# Comments and proposals regarding SC-FEC sublayer indications

Leon Bruckman (Huawei)

- This contribution is in support of comments against the following D1.1 sections:
  - 153.2.4.1.1: fec\_alignment\_valid variable use or remove option, fec\_align\_status behavior
  - 153.2.4.4: Several issues with Figure 153-8

Figure 91-9—FEC alignment state diagram

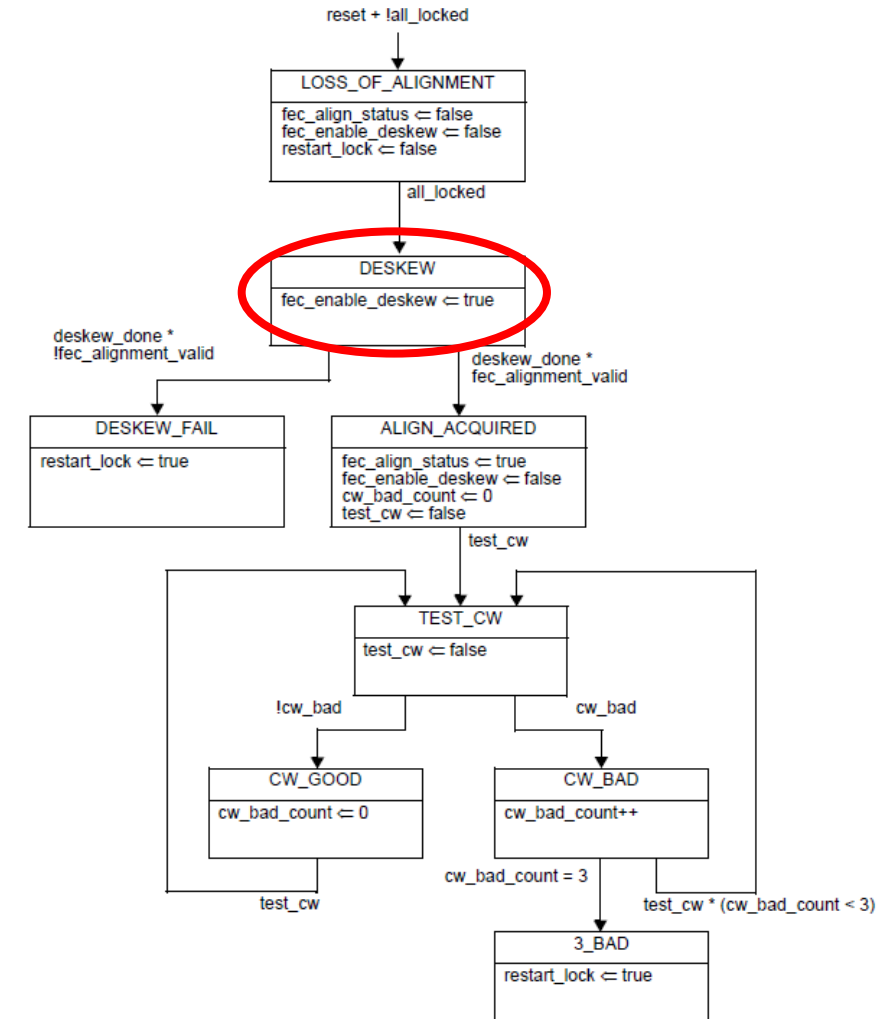
**fec\_enable\_deskew:** A Boolean variable that enables and disables the deskew process. *Received bits may be discarded whenever deskew is enabled.* It is set to true when deskew is enabled and set to false when deskew is disabled.

Assuming `fec_enable_deskew` is set when FAS alignment is lost, communication will be impaired.

- Fix SC-FEC deskew state diagram.
- Consider removing the definition of the `fec_alignment_valid` variable from section 153.2.4.1.1, or use it.
  - It is not used in D1.1 section 153.
  - Note that fixing the SC-FEC deskew state diagram figure may need this variable.
  - Leave it in section 152.5.4.2.1, since section 152 state diagrams refer to section 91 where this variable is used (see this presentation slide 4 Figure 91-9).
